**Hanford Federal Facility  
Agreement and Consent Order**

**Fourth Amendment  
January 1994**

)  
) FOURTH AMENDMENT OF  
) HANFORD FEDERAL FACILITY  
) AGREEMENT AND CONSENT ORDER  
)

In accordance with Article XXXIX of the Hanford Federal Facility Agreement and Consent Order ("Agreement") the Parties hereto agree to the attached amendments to the Agreement.

FIGURE 1

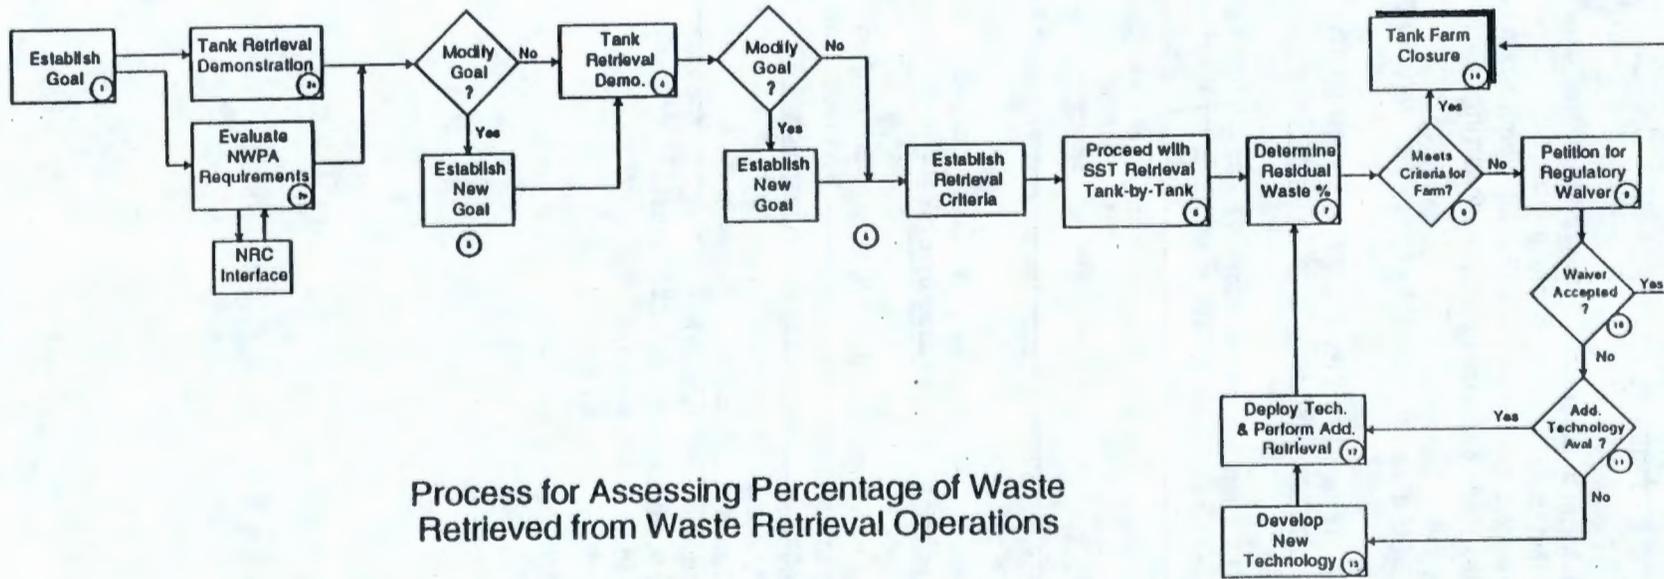
The format for this procedure is to progress through a series of steps as depicted in the generic logic diagram displayed as Figure 1. Each step is briefly outlined and includes elements that constitute completion of the step.

where A% \* = Goal or criteria for waste retrieval percentage.

\* Goal is 99% waste retrieval as defined in M-45-00 in equivalent volumetric measures.
